State of Alaska
Department of Fish and Game
Division of Sport Fish

Nomination Form
Anadromous Waters Catalog

Region Southwest USGS Quad(s) Kodiak A-4
 Anadromous Waters Catalog Number of Waterway 258-52-10012 - 2008
 Name of Waterway Unnamed Stream USGS Name Local Name
 Addition Deletion Correction Backup Information

SUBJECT: Old Harbor Airport Project

Figure 1.

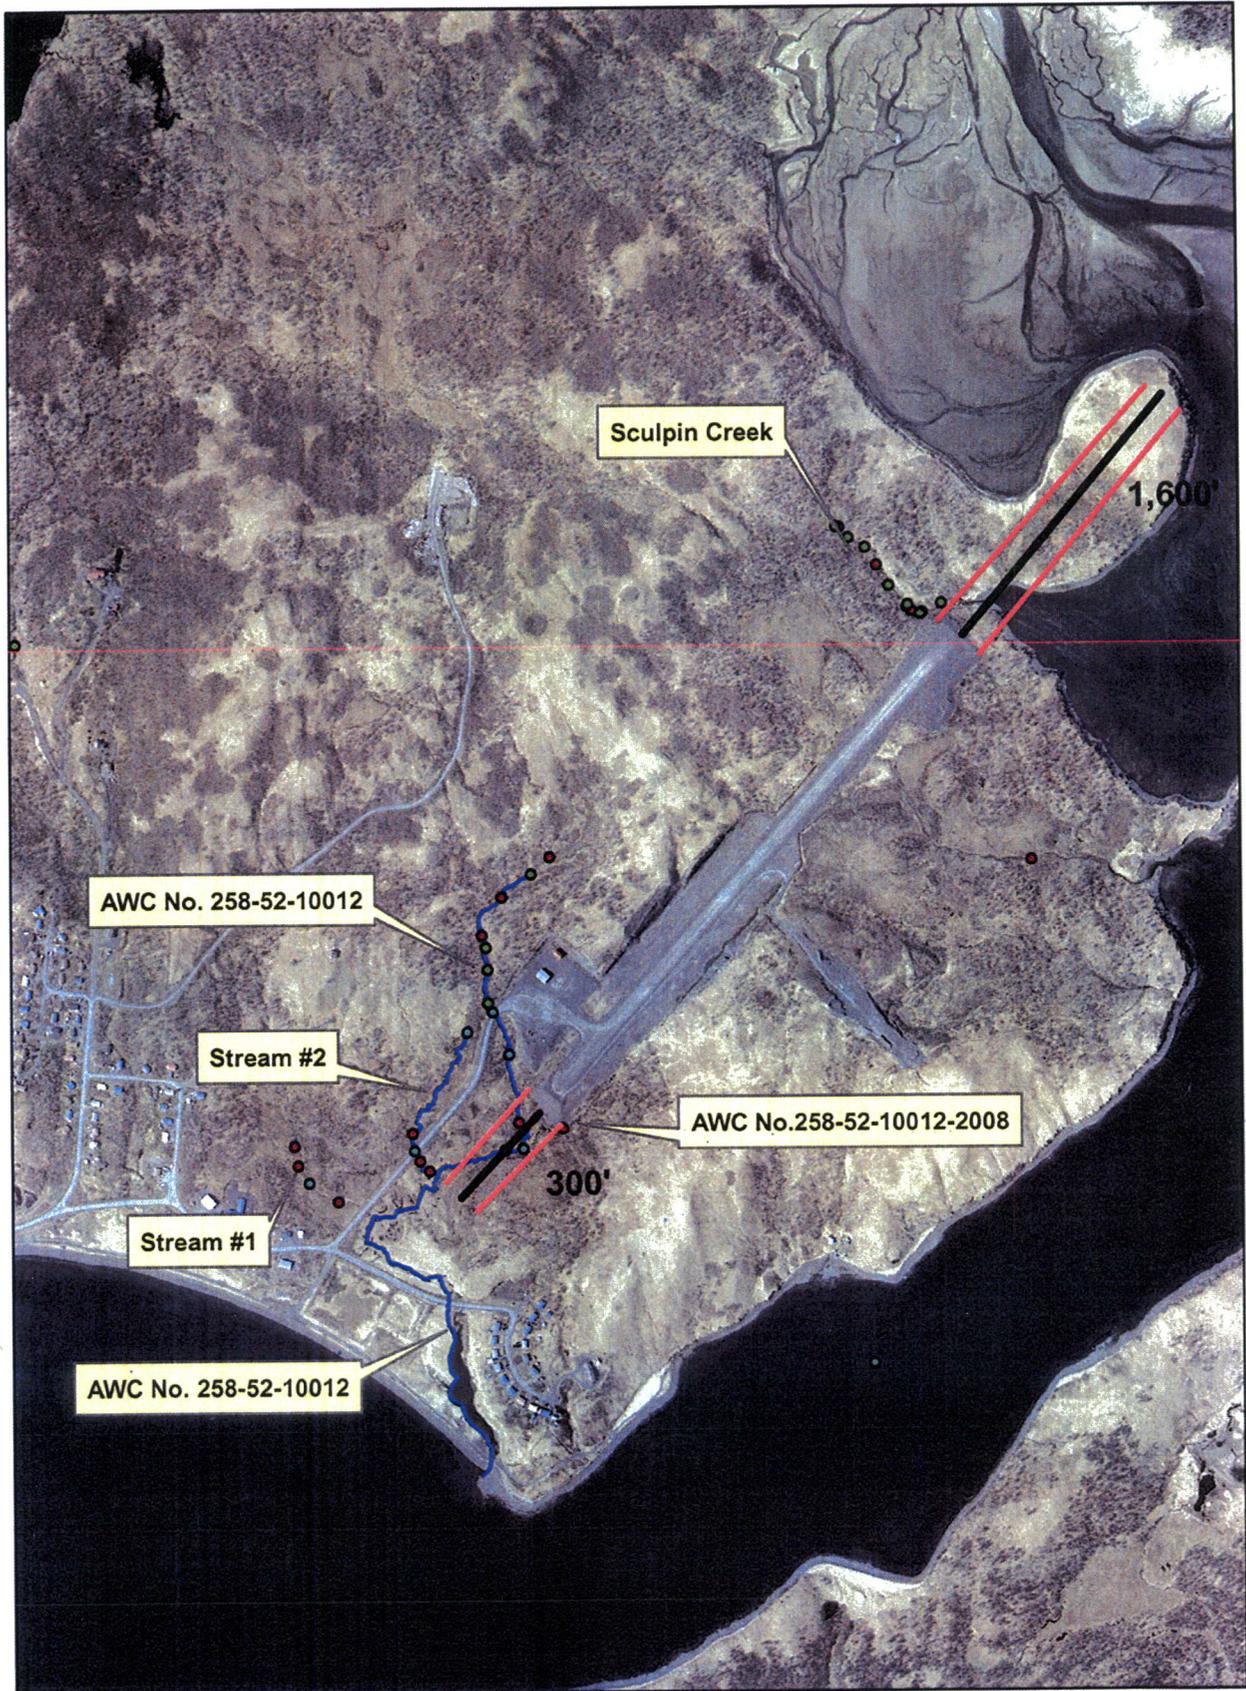
Comments: *Change stream # to 258-52-10022, revise hydrography*
 I used an electrofisher to sample Stream No. 258-52-10012 in Old Harbor. See the June 1-17, 2012 Old Harbor Airport Project trip report. *add book*
move upper/lower pts same
 The true location of the stream is depicted on Figure 1. *Revisy*
Revisy hydrography for 258-52-10012, 2008
Revisy # to 258-52-10022-2008 add coho salmon ref new #12-251

The location of Stream No. 258-52-10012 is incorrectly located in the Anadromous Waters Catalog. I used a hand held Garmin Global Positioning System unit to correct the stream location by walking the stream channel from tidewater to its headwater. The corrected stream location will be nominated to the Anadromous Waters Catalog (Figure 1).

revise stream hydrography for AWC # 258-52-10012 using
CurrentTrack, reposition upper/lower pts,
add coho salmon rearing, change # to 258-52-10022,
shorten and revise hydrography for 258-52-10012-2008
using May9_Tracks, renumber as 258-52-10022-2008 &
extend w/coho salmon rearing
